Office Action Summary	Application No. 10/801,858	Applicant(s) BAUMANN, HERMANN	
	Examiner Thai-Ba Trieu	Art Unit 3748

DETAILED ACTION

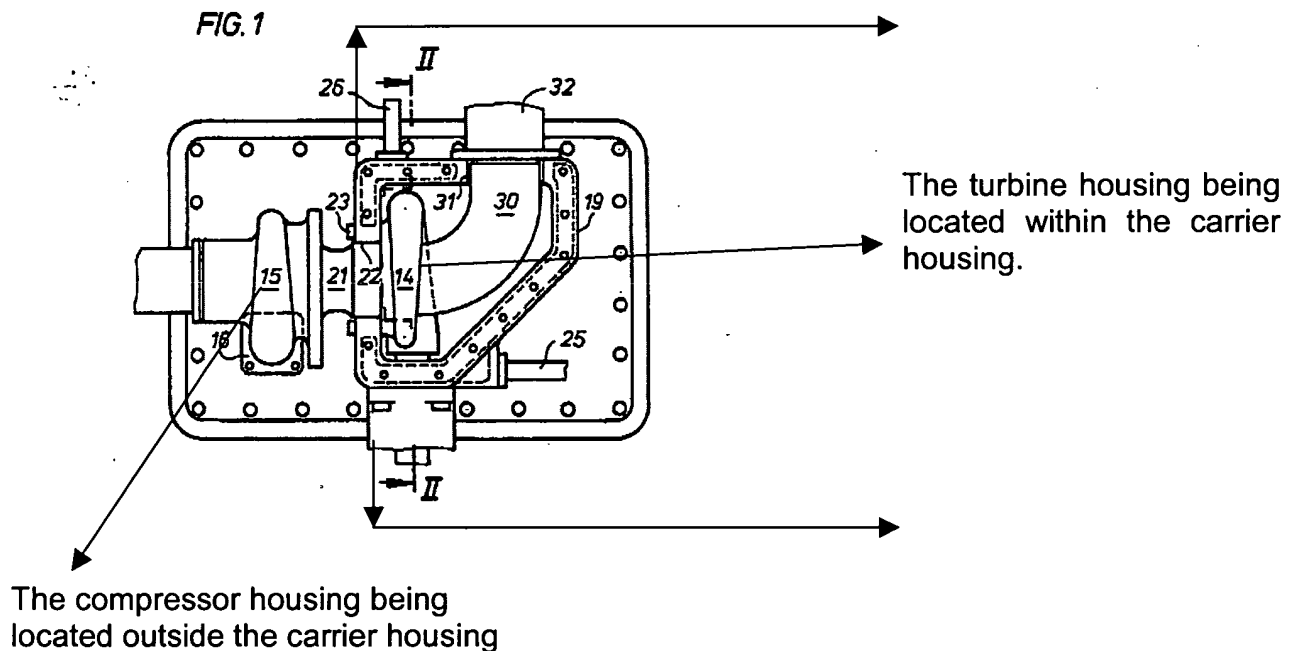
Ruf discloses an arrangement for an exhaust gas turbocharger with a carrier housing (10), the exhaust gas turbocharger (2,3) comprising:

a compressor wheel (Not shown, a well-known component of a compressor) in a compressor housing (See Figure 1),

a turbine wheel (Not shown, a well-known component of a turbine) in a turbine housing (See Figure 1),

However, Ruf fails to disclose the location of the turbine housing and the compressor housing; as well as, the recitation of "the bearing housing being mounted in and attached to the carrier housing by way of a fastening element in a direction perpendicular to an axis of rotation of the shaft".

Norbert teaches that it is conventional in the turbocharger art, to position the turbine housing within the carrier housing and the compressor housing outside the carrier housing (See attached Figure 1; Page 3, line 17-27; and Page 1, Paragraph [0003] of instant application).

It would have been obvious to one having ordinary skill in the art at that time the invention was made, to have positioned the turbine housing within the carrier housing and the compressor housing outside the carrier housing, as taught by Norbert, to improve the efficiency of the Ruf device, since the use thereof would have secured the turbine and minimized the total turbocharger weight.
